Planning Commission
Staff Report
Addendum

SUBJECT: **DR18-124, POWER TRAINING CENTER**

7. **DR18-124 POWER TRAINING CENTER: SITE PLAN, LANDSCAPING, GRADING AND DRAINAGE, ELEVATIONS, FLOOR PLANS, LIGHTING, COLORS AND MATERIALS FOR APPROXIMATELY 0.94 ACRES, GENERALLY LOCATED AT THE SOUTHEAST CORNER OF 144TH STREET AND PECOS ROAD, AND ZONED BUSINESS PARK (BP).**

DRAWING TITLE
LANDSCAPE PLAN

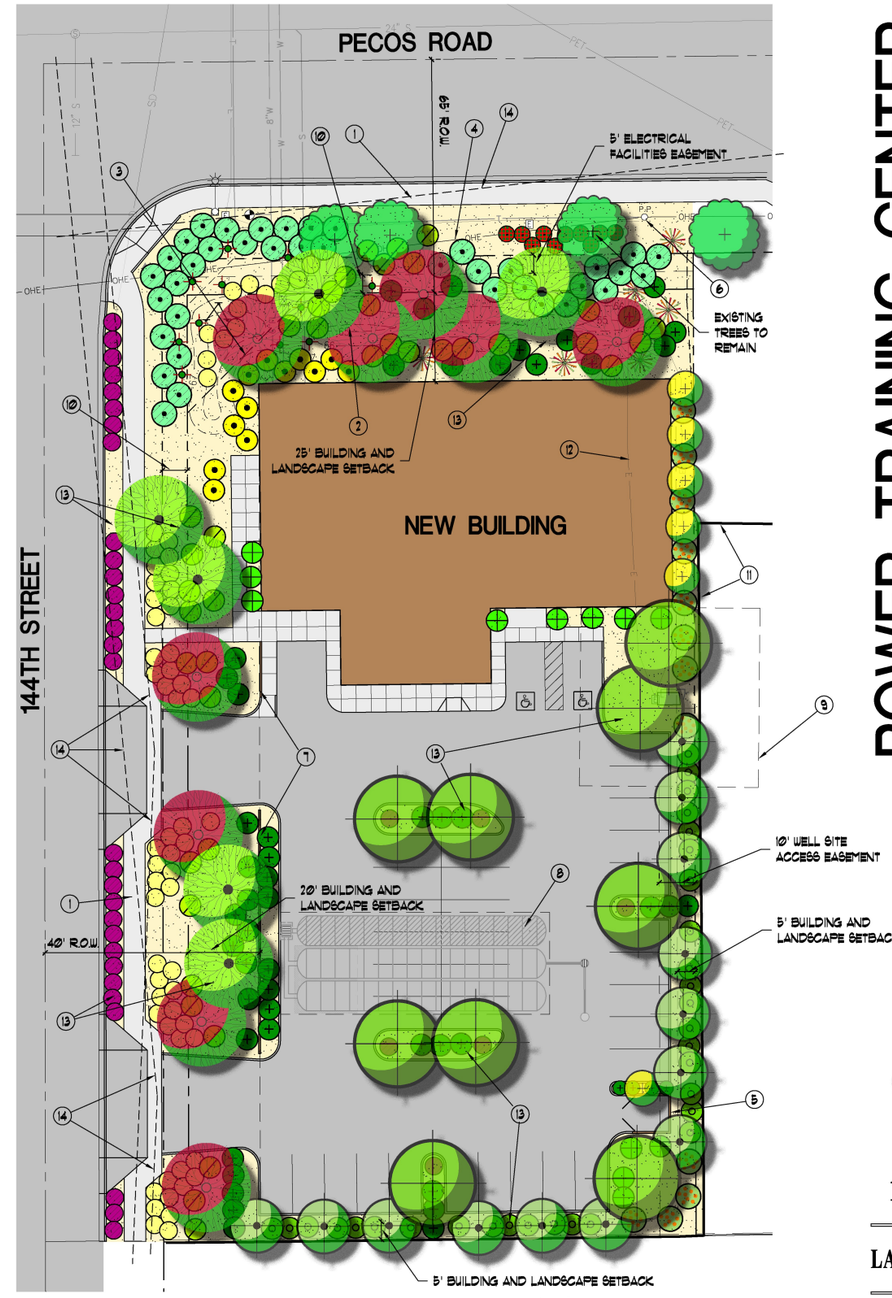
Comment/Question: Brian Johns said he thought the project was going in the right direction and he loves the fact that they are using an alternate material. He said in the future submittals to Staff, it would be nice to see how the variations work. He said that the floor plan is very much a square box. He asked if they were breaking those up with color blocking.
Answer: Nathan Williams shared the Landscape Plan to provide more detail.

Comment: Brian Johns said that he could see it now and they had movement in there.

WALL PANEL TRANSITION DETAIL No Scale **1**

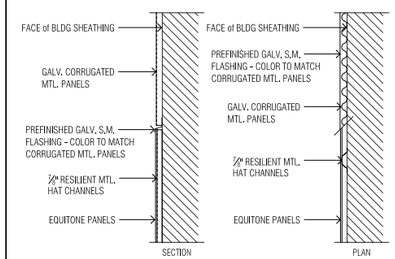
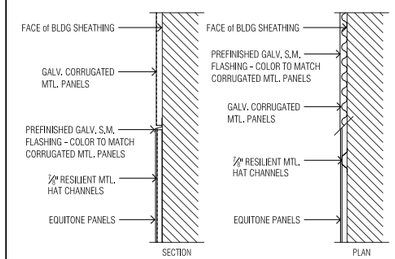
Comment/Question: Daniel Cifuentes said he wanted to commend the applicant on the use of the Equitone fibrous cement panel. He said it would require less maintenance, which is a good

thing. He asked how they would handle where the corrugated portion butts up against the fibrous cement. He said they don't appear to be there yet on the details, but he would want to make sure that they weren't seeing the edge of the corrugation from below. He would appreciate seeing more detail. He said he thought they could get more detail about the fascia detail. He said it seems like it's tacked on in terms of the massing. He suggested whitening that up a bit to make it more prominent. He also asked if they were using that to shade.
Answer: Nathan Williams said the red were cap elements which would provide shade. He asked to clarify if the Commissioner was suggesting a different tone.

SOUTH ELEVATION 0 1 2 4 8 16 **2**

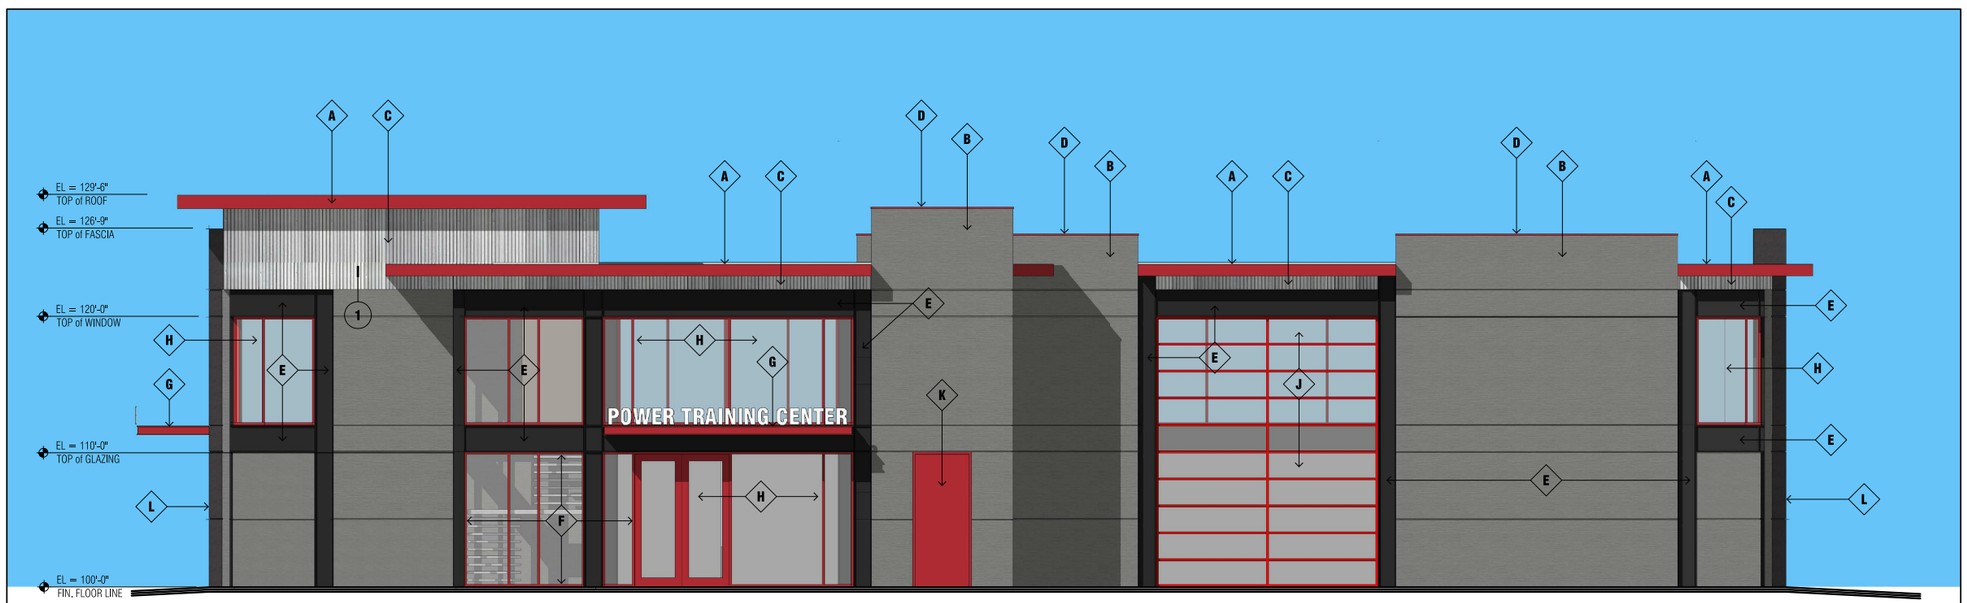
Question: Brian Andersen asked about the south elevation. He said it looks like there is a big overhead door facing the parking lot where the handicapped spaces are located. He asked what the purpose was for that.
Answer: Nathan Williams said that he believed it was a roll-up door. He indicated the location of the training area on the floor plan. He said he thought during ideal weather conditions, the door might be open during training sessions.

Question: Brian Andersen asked about the front entry storefront color. He said he would hate for the applicant to think they could use that red and then when they start construction, find out that they can't use the red. He said the paint doesn't really hold to aluminum that well. He then asked about the window head heights and the roll-up door heights. He said they seem pretty close to the top of the parapet. He said that indicates that there isn't a lot of room for structure and for the parapet to screen the mechanicals on the roof. He said he would have the applicant verify that there is enough parapet up there to screen the mechanical walls.
